**FINAL DRAINAGE REPORT
FOR
MC CLINTOCK STATION LOT A
(VOLLMER ROAD RV STORAGE)**

**October 2022
Project No. 25251.00**

PCD File No. PPR-2245

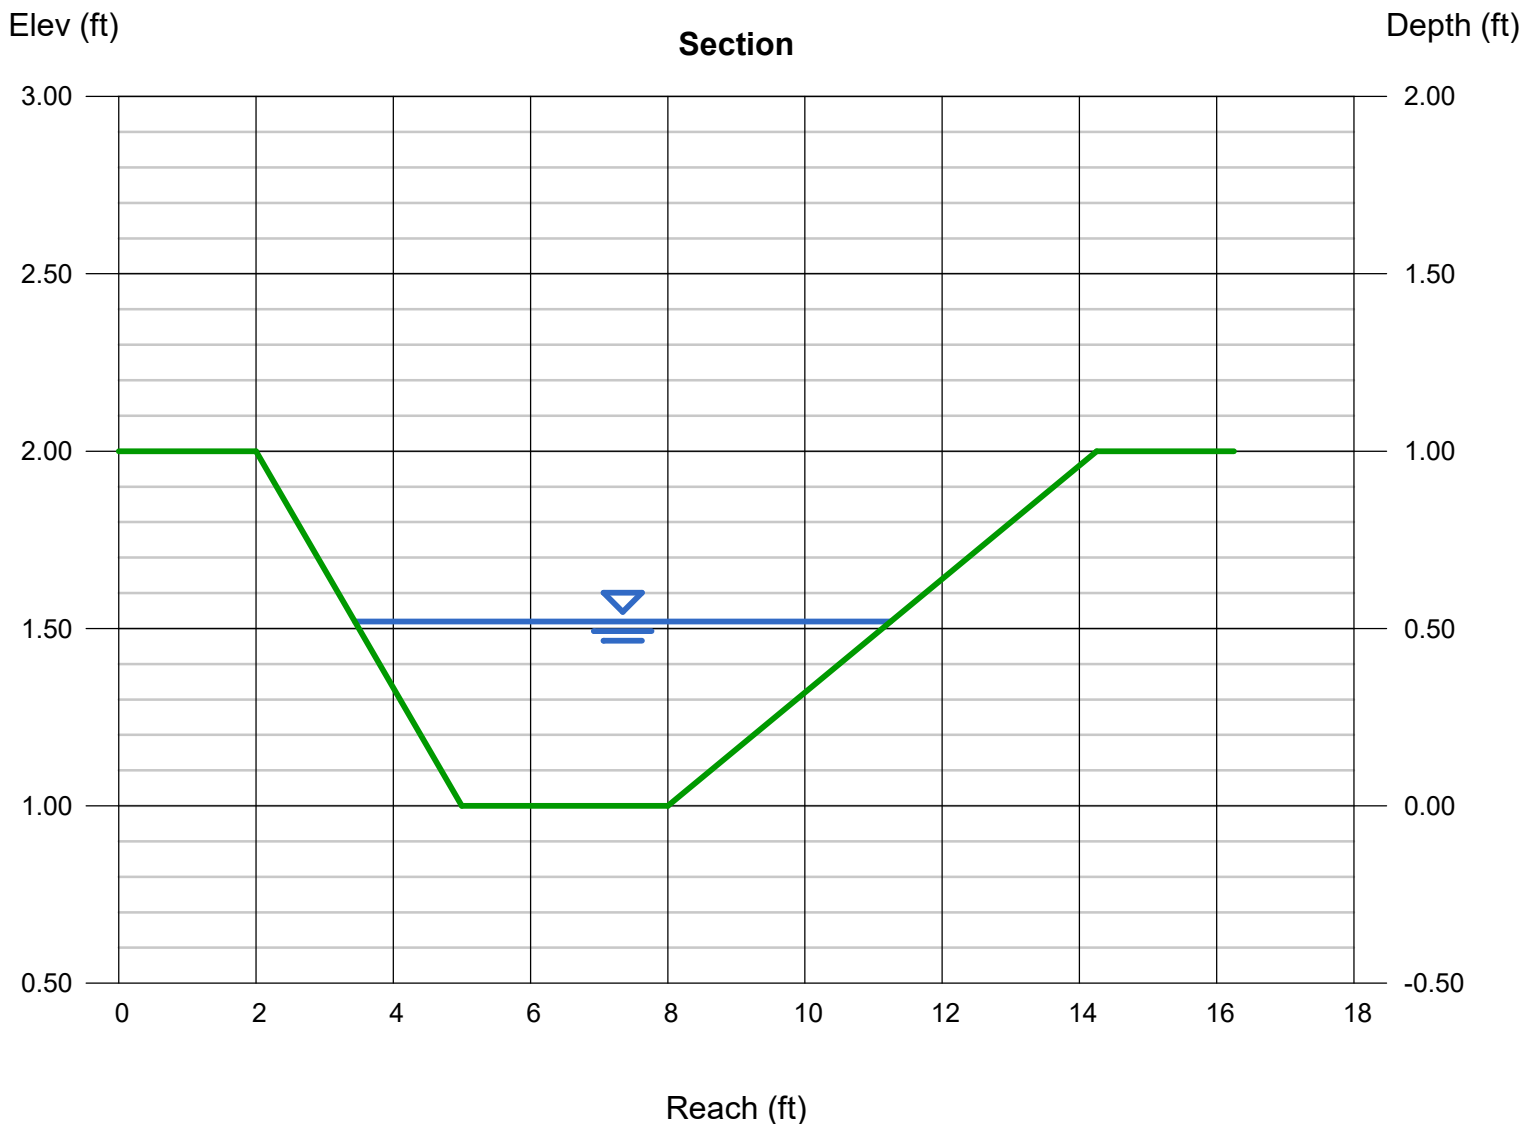
This slope will not achieve positive drainage and will result in standing water within the channel. Increase the slope to 2% to achieve positive drainage.

DETENTION BASIN STAGE-STORAGE TABLE BUILDER

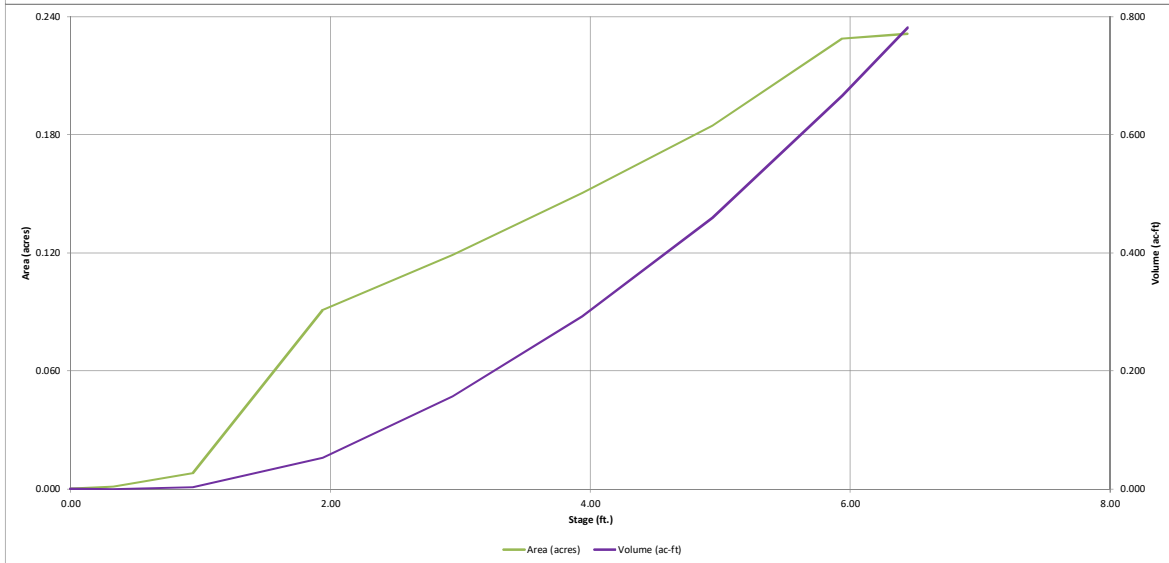
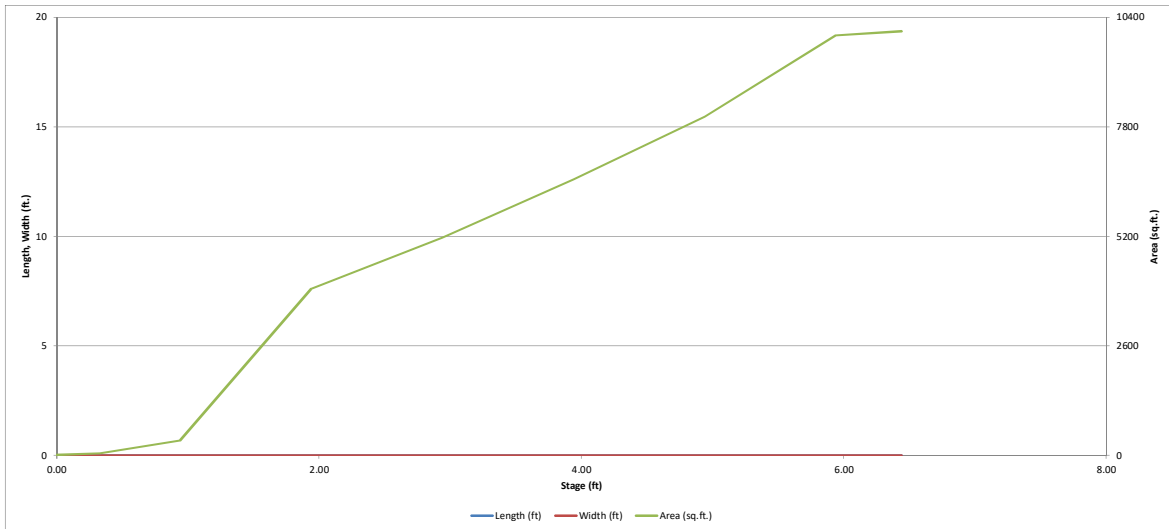
Does not meet 100-yr required volume

Figure 9-35. Expansion factor for circular conduits

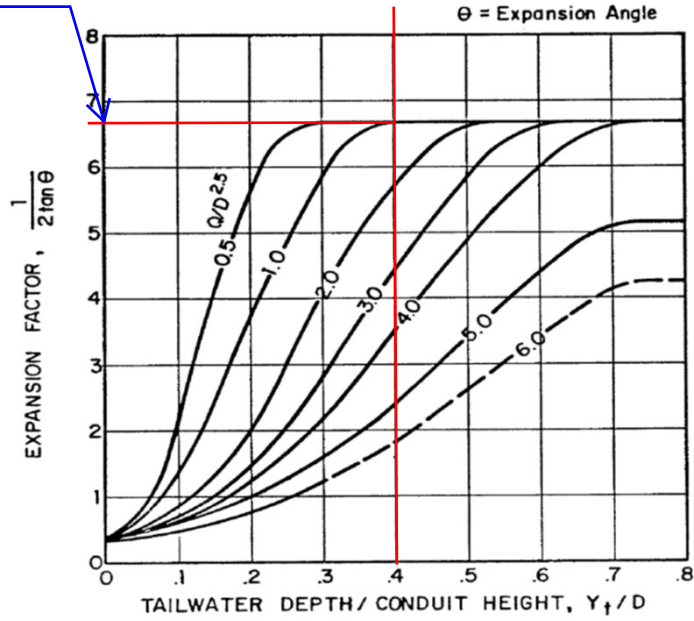
Use expansion Factor close to 6.7 or 6.8

EXISTING DRAINAGE MAP
 VOLLMER RV STORAGE
 JOB NO. 25251.00
 10/24/2022
 SHEET 1 OF 1

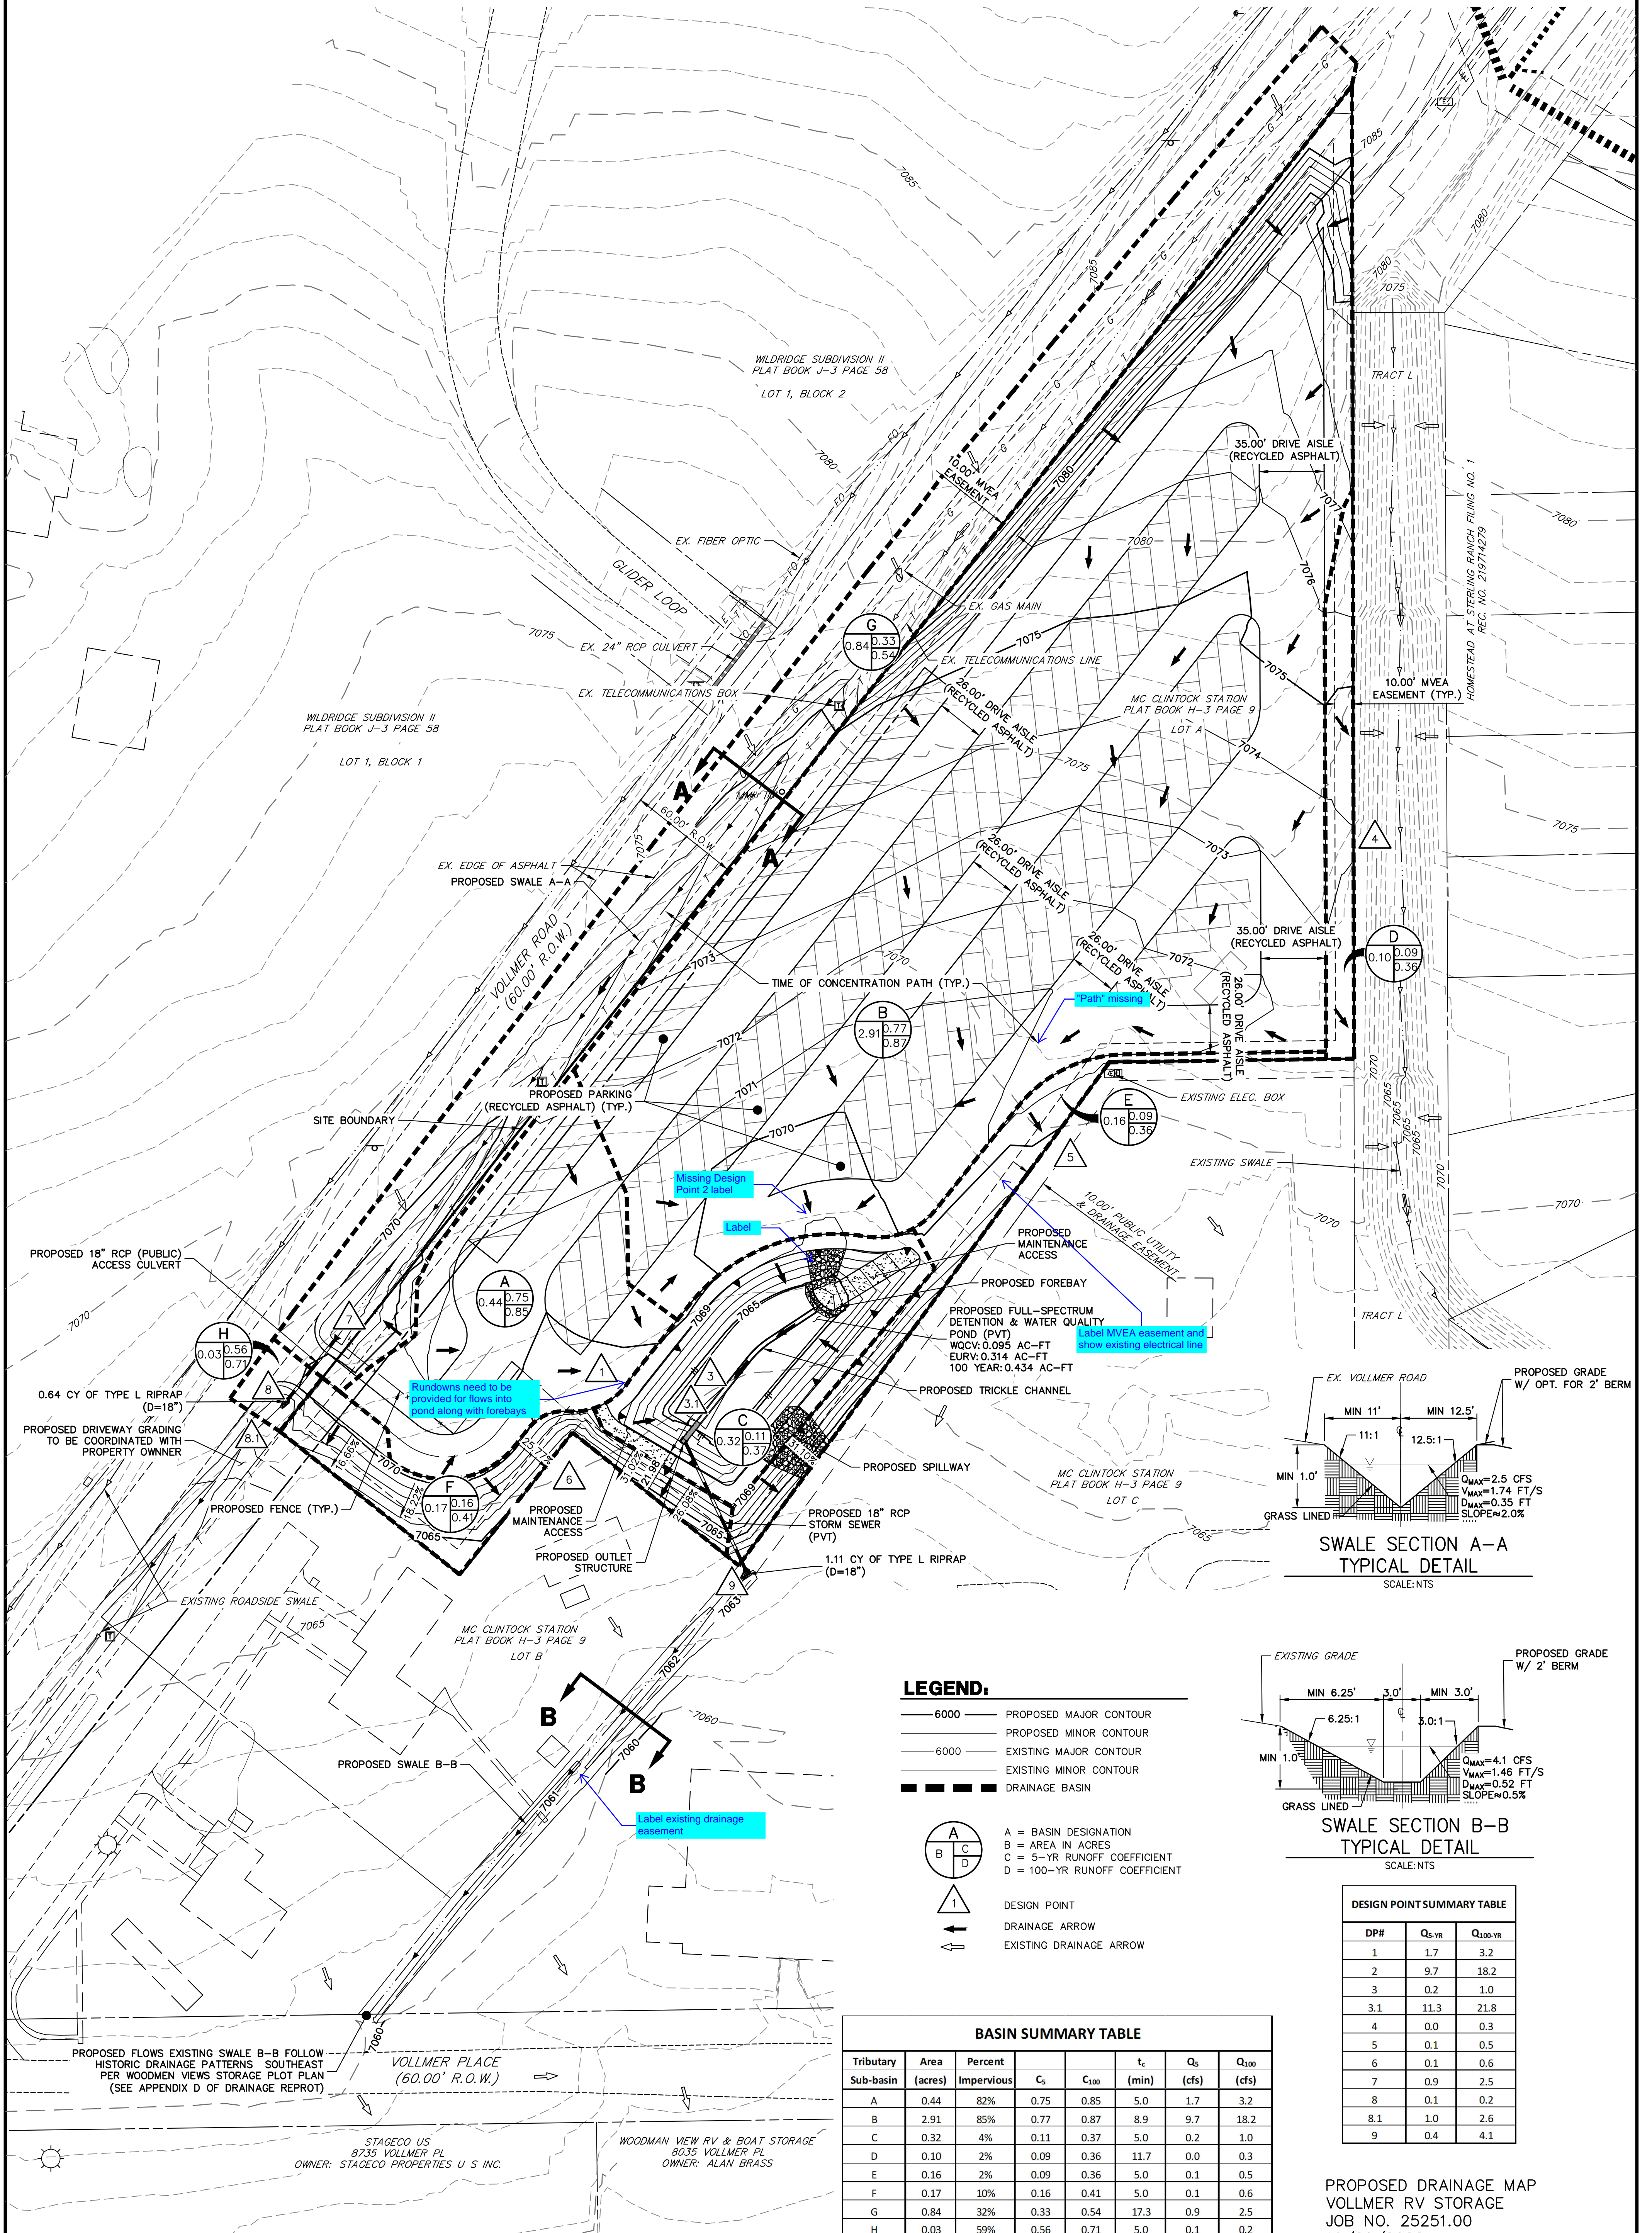
Show and label all existing utilities

VOLLMER RV STORAGE
WQ MAP
JOB NO. 2525100
10/19/2022
SHEET 1 OF 1

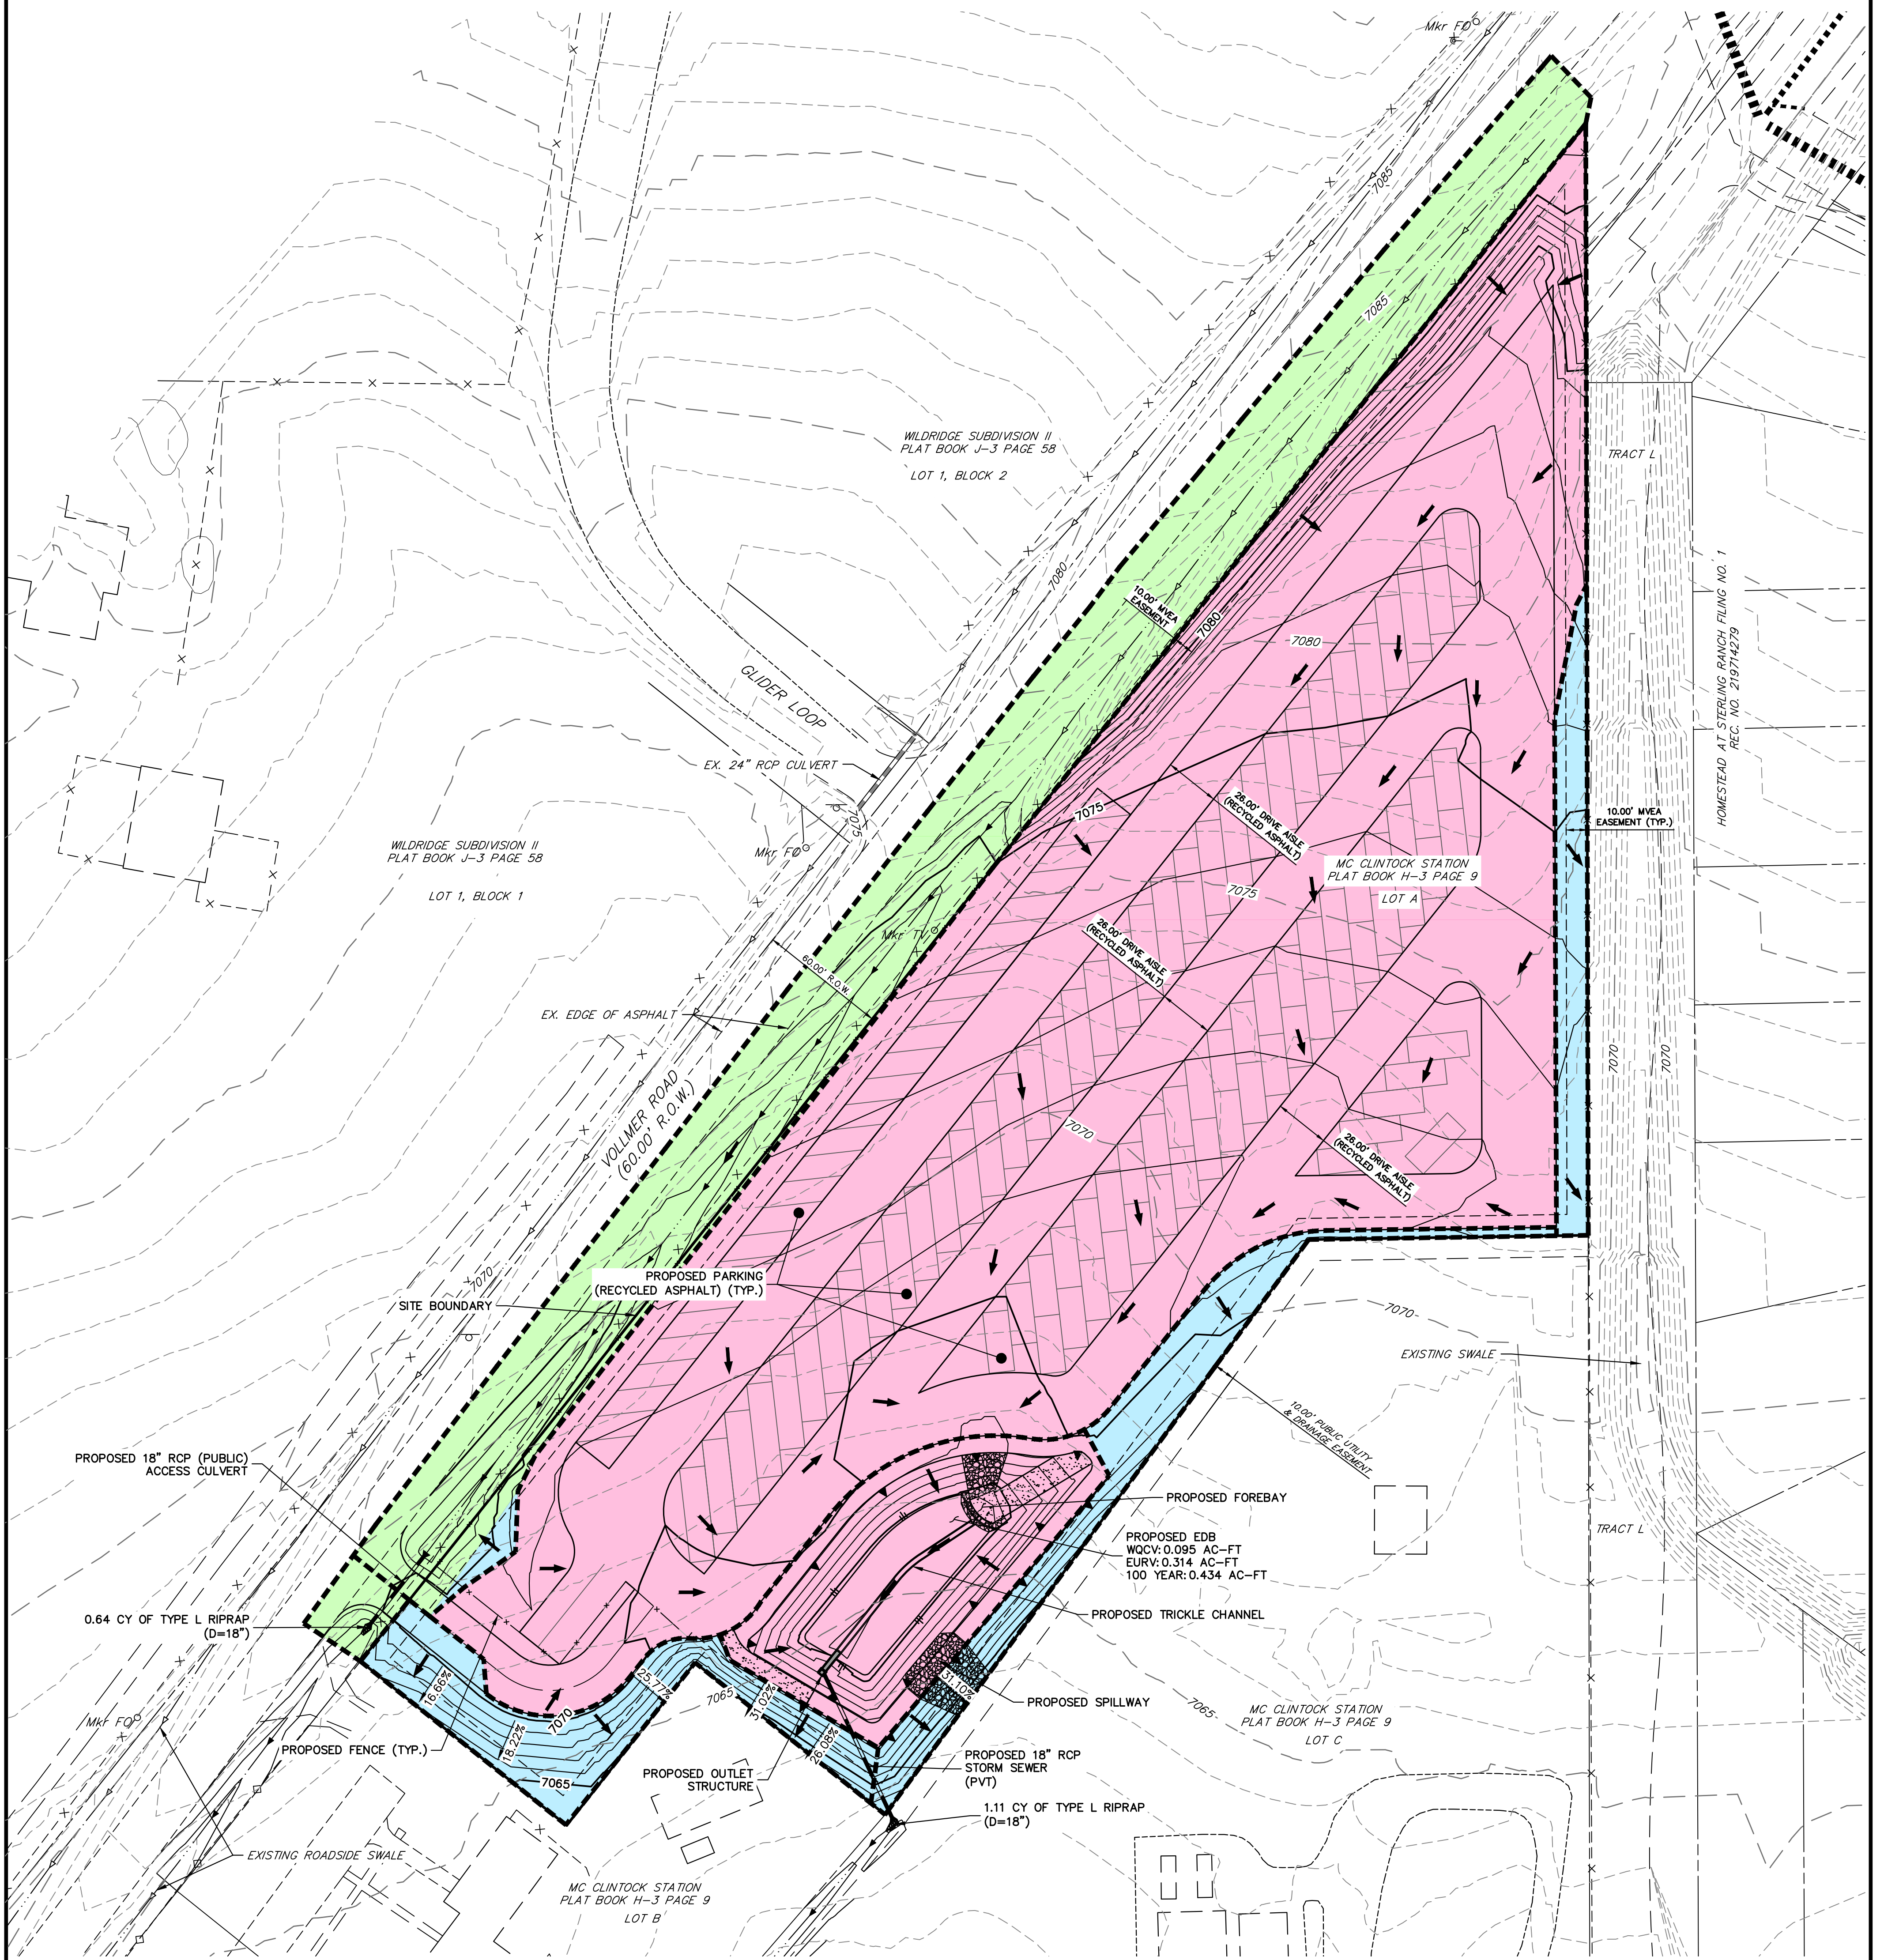
Provide spreadsheet with design of forebay (MHFD BMP spreadsheet)

Label MVEA easement and show existing electrical line
